UNITED STATES PATENT AND TRADEMARK OFFICE

Office Action Summary

10/085,204

DETAILED ACTION

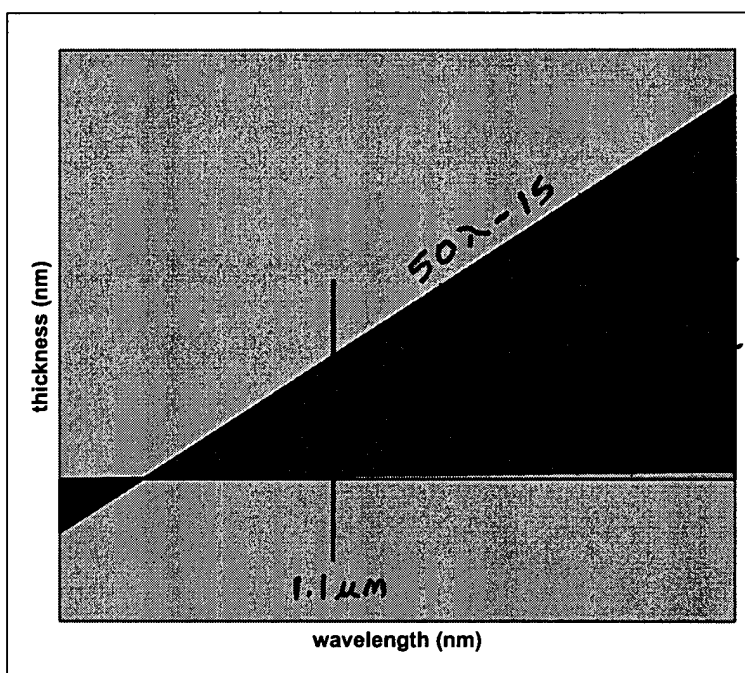
Applicant argued that claim 6 is distinguishable from Ohiso because claim 6 requires the thickness to fulfill a linear relationship (i.e. $y = mx + b$). However, applicant's argument is incorrect. The claim only requires a thickness $< 50 \lambda - 15$. This does not require a linear relationship to hold between the thickness and the wavelength. This wording of the claim only requires the thickness to fall below the $50 \lambda - 15$ line. For example, see the graph on the following page. Ohiso's thickness, as noted above in the 103 rejection, is disclosed to be less than around 95-130 nm. Even taking into account the proposed amendment to correct this

equation (discussed below), this range clearly overlaps with the claimed range as noted in the 103 rejection.

In total, the claim requires the wavelength to be greater than 1.1 microns and the thickness to be less than the $50\lambda - 15$ line. The claim does not require a linear relationship, only a thickness that falls into the hatched region of the graph above.

The examiner has a further problem with the claimed equation. Again, as noted in the 112 rejection above, it is believed that this equation is incorrect, regardless of the fact that $50\lambda - 15$ is disclosed in the specification. The applicant is mixing units in the equation, which leads to a confusing result. The examiner contends that this equation does not properly convey the intended meaning of applicant's invention. Table 2 on page 85 clearly shows the applicant's intention is for 1.1 μm wavelength to correspond to 40 nm thickness, for 1.3 μm to correspond to 50 nm, and so on. Page 85 lines 20-21 clearly state that the thickness and wavelength are to be in

These thicknesses are one thousand times the intended thicknesses listed in Table 2. Thus it is proposed that to correctly claim the invention applicant must change the equation to:

$$0.05 \lambda - 15$$

This should be changed in both the claims and in the specification. This will not be deemed new matter because it is a clarification of a clear mathematical error understood by one skilled in the art.
